Subject: Bug in 3K CRAM

REWORK INSTRUCTION FOR CONTROL MODULE WITH 3K CRAM.
(REFER TO FIGURE1)

Title
ASSEMBLY, P.W.
3K CRAM

FIGURE 1

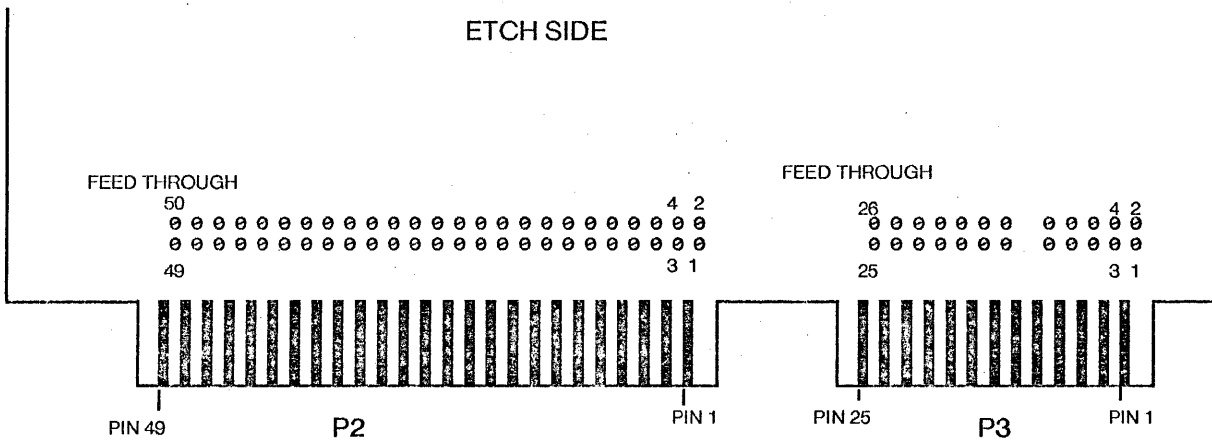
- CUT ETCH TO FEED THROUGH P2-14 (ETCH SIDE)
- CUT ETCH TO FEED THROUGH P2-12 (ETCH SIDE)
- CUT ETCH BETWEEN U51-8 AND U51-7 (ETCH)
- CUT ETCH TO U70-10 (ETCH SIDE)

- ADD JUMPER FROM U37-12 TO U37-7 (ETCH)
- ADD JUMPER FROM U51-7 TO U39-3 (ETCH)
- ADD JUMPER FROM U68-9 TO FEED THROUGH P2-14 (ETCH SIDE)
- ADD JUMPER FROM U68-12 TO FEED THROUGH P2-12 (ETCH SIDE)
- ADD JUMPER FROM U25-11 TO FEED THROUGH P3-7 (ETCH SIDE)
- ADD JUMPER FROM U25-3 TO FEED THROUGH P3-8 (ETCH SIDE)
- ADD JUMPER FROM U25-4 TO FEED THROUGH P3-9 (ETCH SIDE)
- ADD JUMPER FROM U25-6 TO FEED THROUGH P3-10 (ETCH SIDE)

REPLACE U51 WITH SW3K PROM (82S126)
